# Ni Tennis Court Appeal

1221 Lomita Lane, Carpinteria

# E-mails re: Project Revisions

8/6/18-8/16/18

# PDF attach to email: Ni Grading Plan Rev 8-16-18.pdf 695 KB)

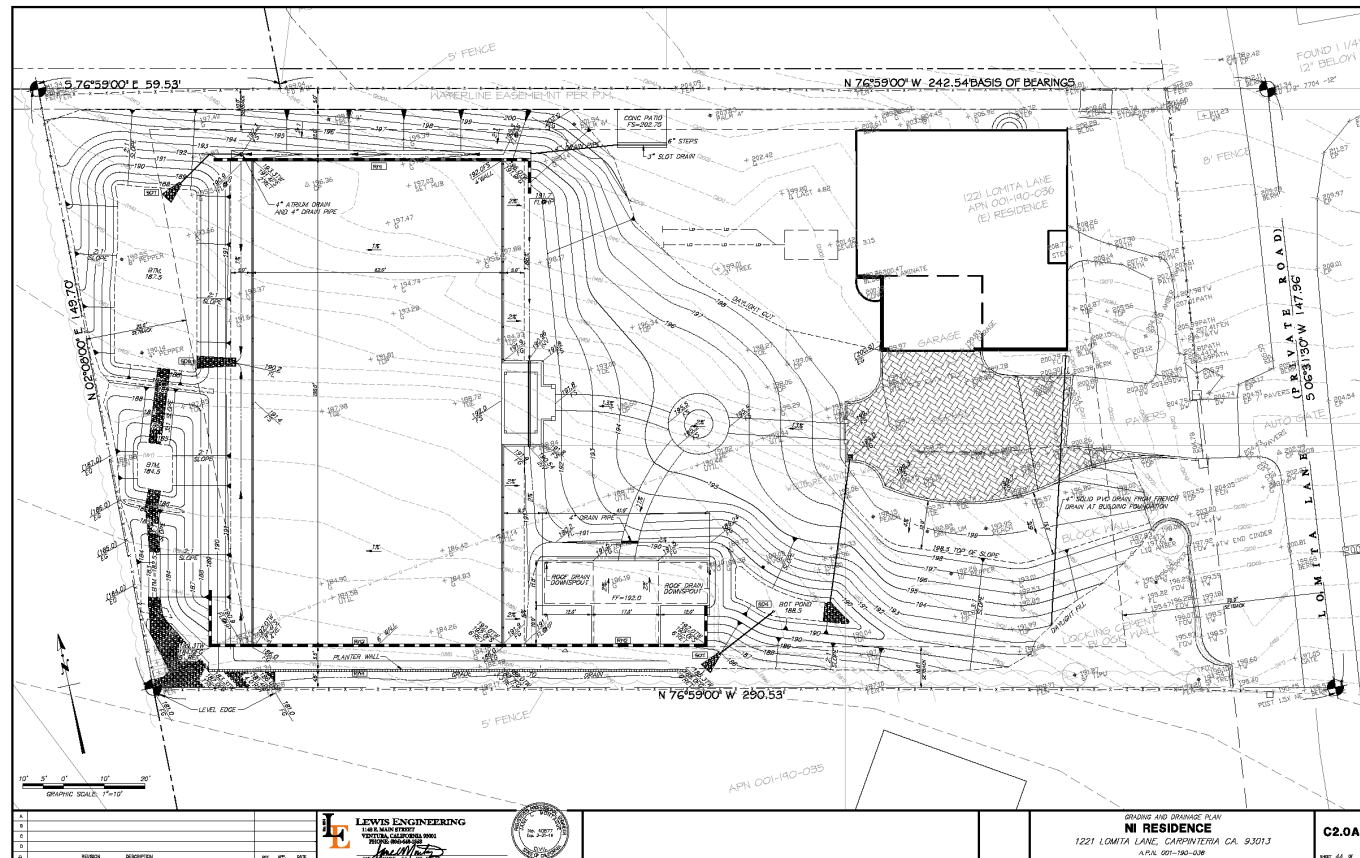
I think we have a plan that addresses all the issues and concerns regarding the minor changes vs the approved and permitted plan. Attached is a plan showing the following:

- 
- All setback lines shown.
  - Wall at the driveway (from the Gones plan) and wall at Ella's Garden (from our earlier version) have been eliminated. All we have is some sliver fill and a wider area next to the driveway. This should alleviate any concerns over impact to the southerly neighbor.
  - Secondary wall south of the tennis court is shown as a garden wall. Its purpose is to create a linear planter screen strip along the south of the tennis court in addition to building up the grade a bit where needed.
  - We added the rock in various locations which we talked about in our previous discussion.
  - The concrete slab (for the future un-permitted portable Tuff Sheds) is further from the southerly neighbor's home than it was in the Gones plan.

So, other than massaging the grades overall to soften the site grading, radically reducing the retaining walls and moving the retention basins to the west end (where they will appear the most natural and coordinated with the existing terrain), the changes are minor. The Nis and I are confident this plan addresses all your concerns. The construction is scheduled to begin soon and we'd like to address these minor changes as field changes under the current permit and not as major design revisions that would trigger a new Planning application. We feel the changes don't really impact any concerns that Planning might have and are essentially grading and drainage revisions.
